ECE/TRANS/WP.29/GRE/2008/17  
18 January 2008

Regulations Nos. 6, 7 and 48

Proposal for Supplement 15 to the 02 series of amendments Regulation No. 7  
(Front and rear position (side) lamps, stop lamps and end-outline marker lamps)

Submitted by the expert from France \*/

"Annex 1

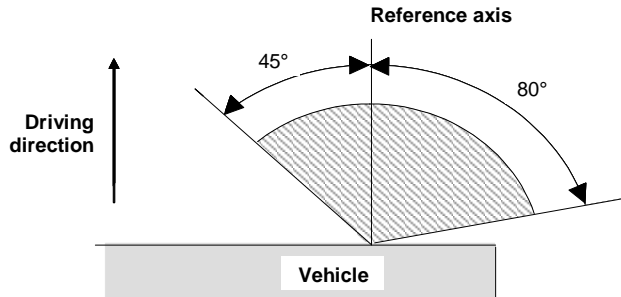
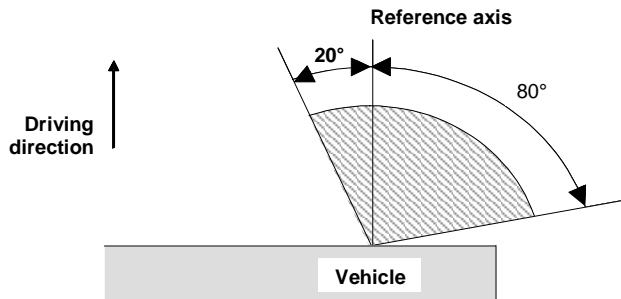
Annex 1, amend to read:

(b) for category S3 or S4 stop lamp for which they are 10° above and 5° below the horizontal;

Front position lamps on and above the H plane.  
End-outline marker lamps

Front position lamps under the H plane

Rear position lamps.  
end- outline marker lamps

The current visibility requirements were written in the early 1970s. They were easily fulfilled in those times because the shapes of the vehicles were simple and rather boxy. In recent years, fuel-efficient aerodynamics and pedestrian protection have led to more contoured shapes making impossible the fulfillment of the 15° down and 45° inboard (15D-45inboard) visibility requirement of the front position lamp. This proposal tends to eliminate this requirement;

- (a) Reducing the interior visibility angle from 45° to 20° under the H plane has no impact on the distance of visibility of the vehicle observed by pedestrians or other road users along its longitudinal median plan;
- (b) In the case of a vehicle with 1400 mm between the reference axis of the front position lamps, this angular reduction, as seen by an observer squatting down on the median longitudinal plan of the vehicle, leads to a minimal change of the visibility distance of just 1.22 m:

With the current visibility angle, the lamp is visible at  $D_1 = 1,400 \times 0.5 \cotg 45^\circ = 700$   
 With the proposed visibility angle, the lamp is visible at  $D_2 = 1,400 \times 0.5 \cotg 20^\circ = 1,923$   
 The “danger” distance is increased by a modest  
 $D_2 - D_1 = 1,400 \times 0.5 (\cotg 20^\circ - \cotg 45^\circ) = 1,223 \text{ mm}$
